Certificate of Appropriateness
BAR # 25-0078
Downtown Mall – 4th St. E & 2nd St. W.
Owner: City of Charlottesville
Applicant: Riaan Anthony, Director, Parks &
Rec Project: Repairs to Mall vehicular crossings
at 4th Street East and 2nd Street West

Certificate of Appropriateness Application

- Applicant submittal: Line and Grade Civil Engineering drawings *Downtown Mall Crossing*, dated 4/18/2025, 11 sheets.

DOWNTOWN MALL CROSSING

1 SECOND STREET REPAIR PLAN
1" = 5': 0 5 10

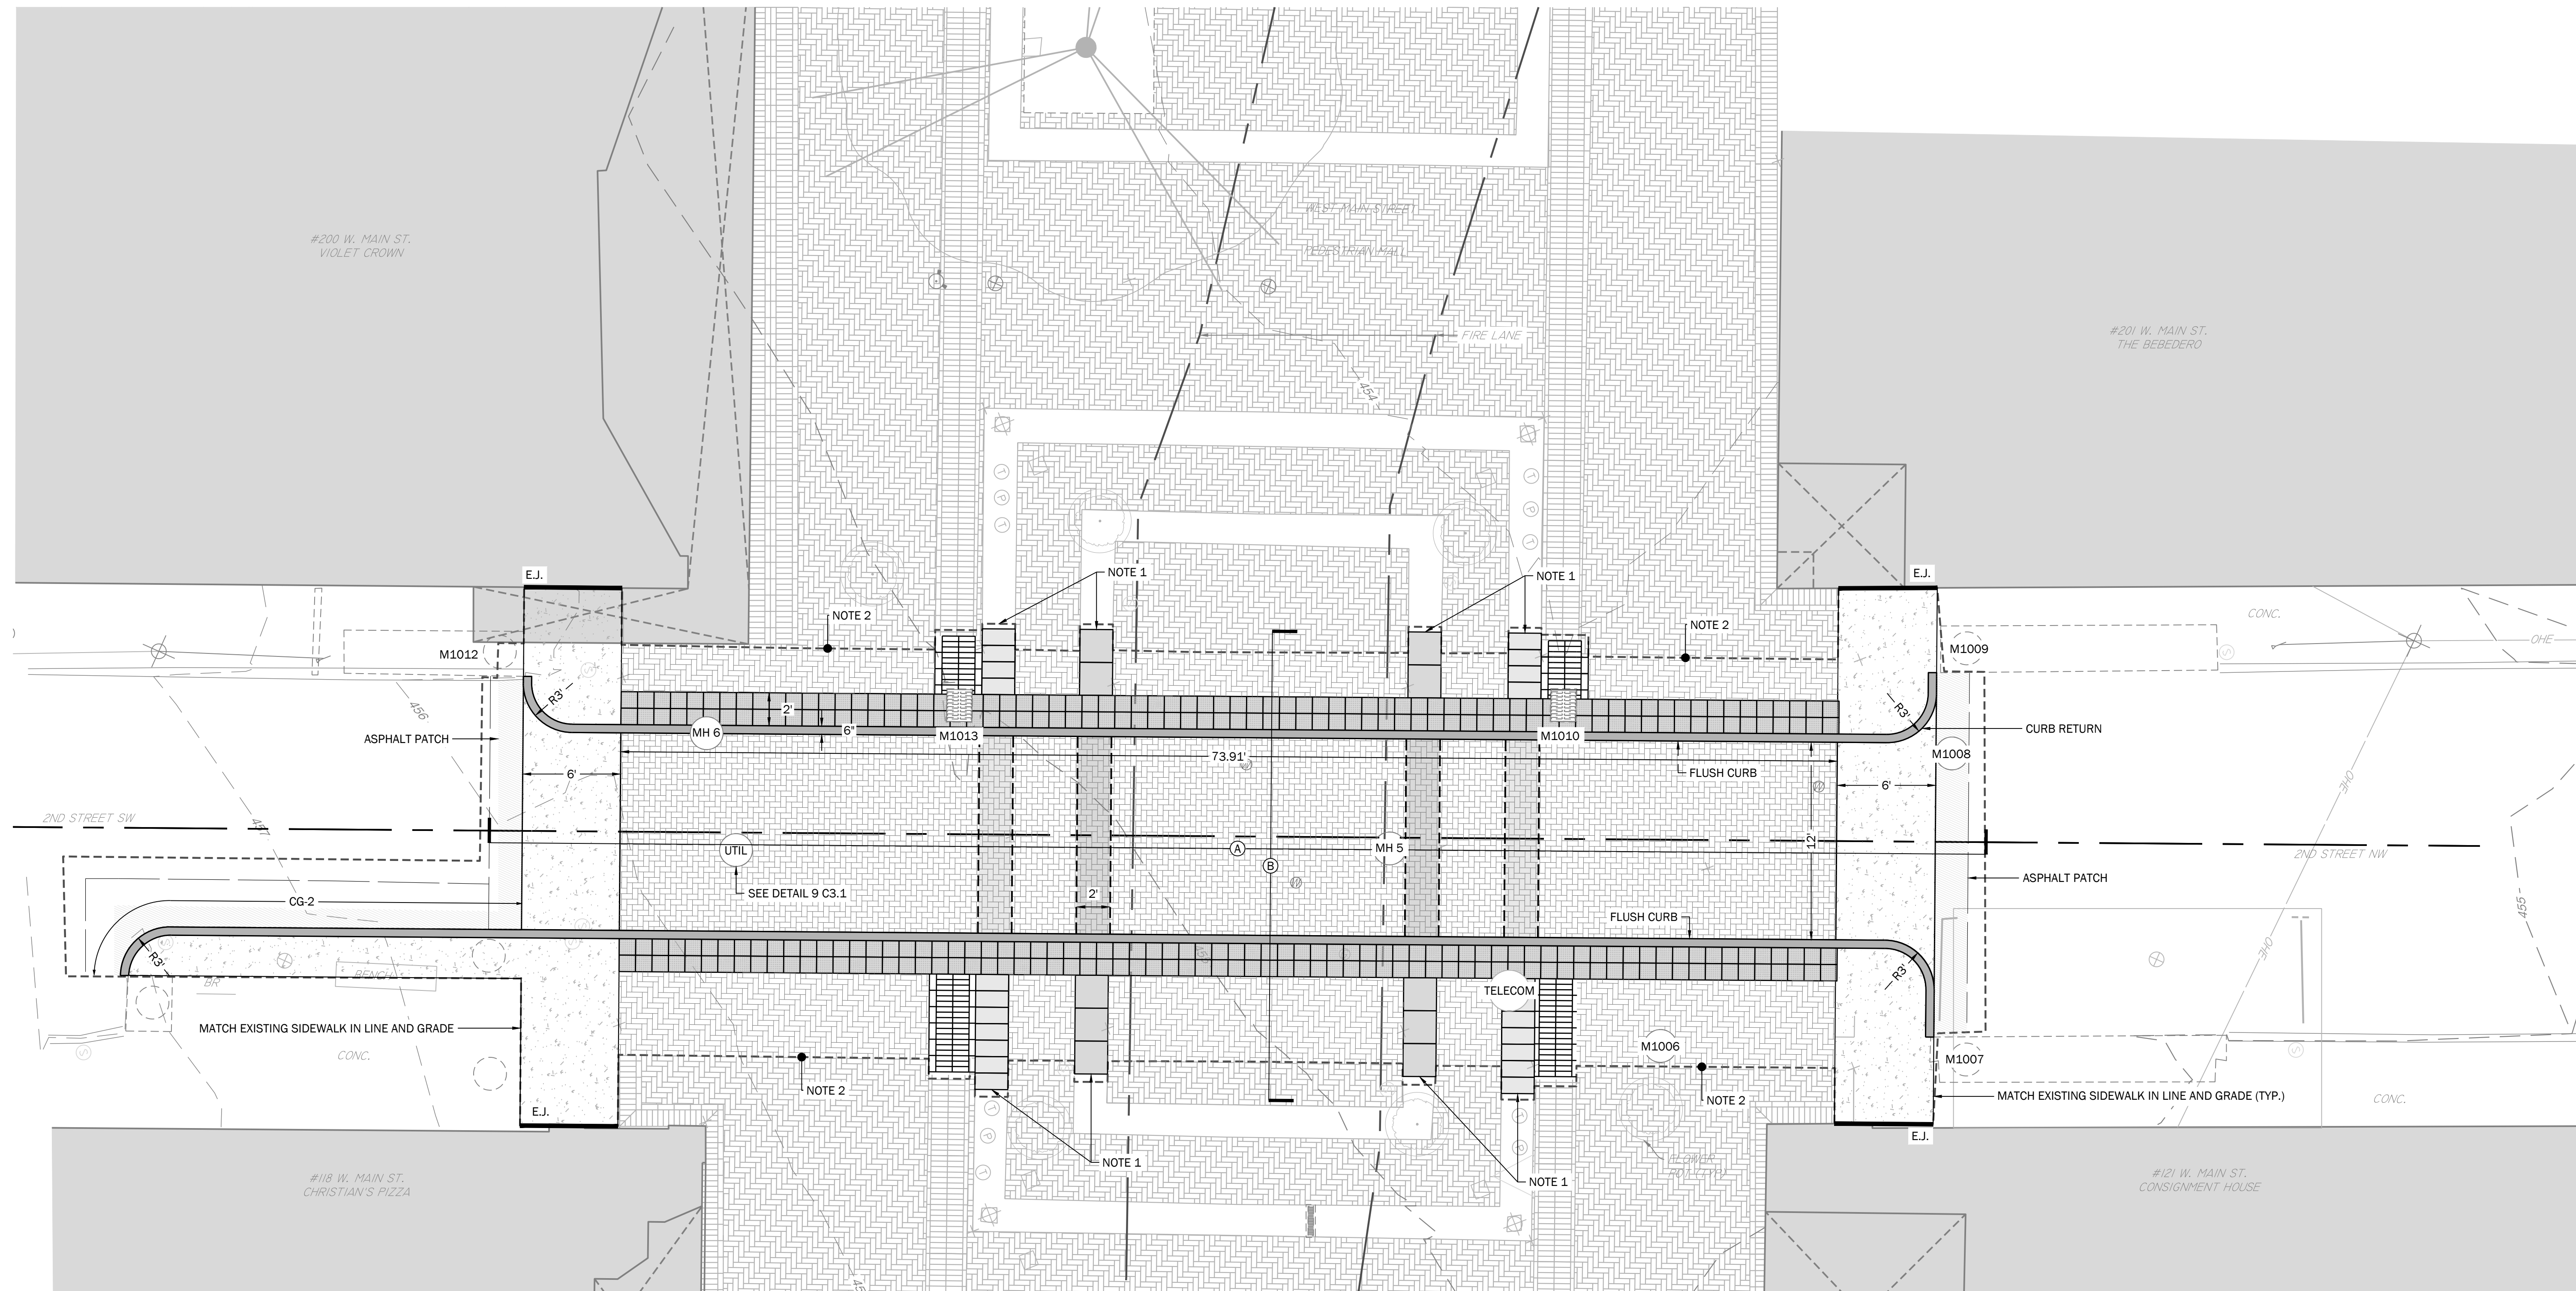
Having considered the standards set forth within the City Code, including the ADC District Design Guidelines, I move to find the proposed Repairs to Mall vehicular crossings at 4th Street East and 2nd Street West satisfy the BAR's criteria and are compatible with the Downtown Mall and this ADC District, and that the BAR approves the application as submitted with the following conditions:

- The soldier course border should continue up to the tactile strip [band] but not across the vehicular lane.
- The BAR recommends there should be a landscape architect involved who is qualified to advise on historic landscapes.
- The BAR would like to be included in material and color selection and be provided a workmanship mock-up to review.

- BAR is satisfied with the material and color selected for the two grey bands.
- Staff expressed to the applicant the brick coursing should be planned so as to not require splits; however, the applicant expressed that some may be necessary. The BAR should discuss what level of precision can reasonably be achieved and what will be acceptable.
- At both crossings, the existing soldier/stretcher courses at the corners must be retained (outside the travel lane).

- Where the tactile pavers are shifted, the soldier/stretcher courses will be extended.
[Note: A uniform, integrated brick coursing is ideal for the integrity and durability of the travel lanes. The herringbone pattern will be used throughout, with no soldier course band at either end.]

- At the SW corner of the 2nd Street crossing, reinstall the soldier/stretcher course where it had been removed.

- 1) At both crossings there are brick bands at the perimeter of a soldier course with a single stretcher.
 - a. Outside the new travel lanes (where the tactile pavers are moved in), I expect the BAR will want the soldier/stretcher courses installed to continue the existing; not repaired with the herringbone pattern. This includes repairing the bands on 2nd Street (at the building corners on the SW and NW) where it appears they were previously removed.

- b. Inside the new travel lanes (between the tactile pavers) at the transition to concrete, is there a reason the two ends will be herringbone, not the band of soldier/stretcher courses?

- 2) The gray bands within the new travel lanes. Conform these will align with the corresponding granite bands and be coursed out to use only full and half bricks, no splits. For the grey brick bands, I agree that uniformity in size is critical, so it makes sense to use brick and not change to another material, but be prepared for the BAR to ask if they can be granite, whether large pavers or cut to brick size to maintain coursing. You also mentioned the color. Not sure where the BAR will fall on that, whether they will want a “match” or something “similar.” Be prepared to explain the options available, and anticipate they might OK the design, but still want to approve the color

- 3) Runnels within the new travel lanes. They were continued through the lane in the design approved for the 2008 re-bricking. I suspect it will be a toss-up whether to include them in this work—even if the stretcher/double-solder/stretcher bands are laid flush with the adjacent bricks, and not tilted for drainage. Be prepared to discuss the what ifs.

1A: soldier course could be added anywhere outside of the vehicular zone. However, these would need to be constructed of non-reused brick. The salvaged brick does not bond well with mortar (having been reused many times) so the soldier course would not match the remainder of the soldier courses, it would be from new brick.

JW 5/15: I know Daniel mentioned this, but bricks are reused all the time, so I’m not convinced extending and reinstalling the soldier/stretcher bands would require new brick.

- 1) The existing soldier/stretcher courses at the corners must be retained (outside the travel lane).
- 2) Where the tactile pavers are shifted, the soldier/stretcher courses will be extended.
- 3) At the SW corner of the 2nd Street crossing, reinstall the soldier/stretcher course where it had been removed.

1B: it is not advisable to put soldier course brick in the vehicular travel way. Refer to Line and Grade's forensic Memo from 2022.

JW 5/15: I concur.

2: Correct. The gray brick will align with the granite. That said, our survey seemed to indicate that some of these installations are not "square" leading to a slight slant across the crossing. It is not easy to confirm this but our intention for the installed material is that it would be an extension of the granite bandings (on either side) and that full/half brick will be used as you say.

JW 5/15: I suspect the solution will require accepting some slight misalignment of the brick bands and the granite pavers. That would be my preference to splits. It would be helpful for the design team to explain to the BAR the level of precision that can reasonably be achieved.

3: It is not advisable to put the runnels across the crossings. It was also not advisable in 2008, however it was done due to influence or BAR and UVA experts on Halperin. If runnels are

installed across the vehicular crossing it is not a matter of "if they break" but when they break. Therefore, it is our recommendation to not continue the runnels across the vehicular crossing.

JW 5/15: I concur they should be excluded. It makes sense mechanically and, if nothing else, we have already altered these crossing, with that work demonstrating that, if necessary at a later date, the original pattern/design can easily be reintroduced.
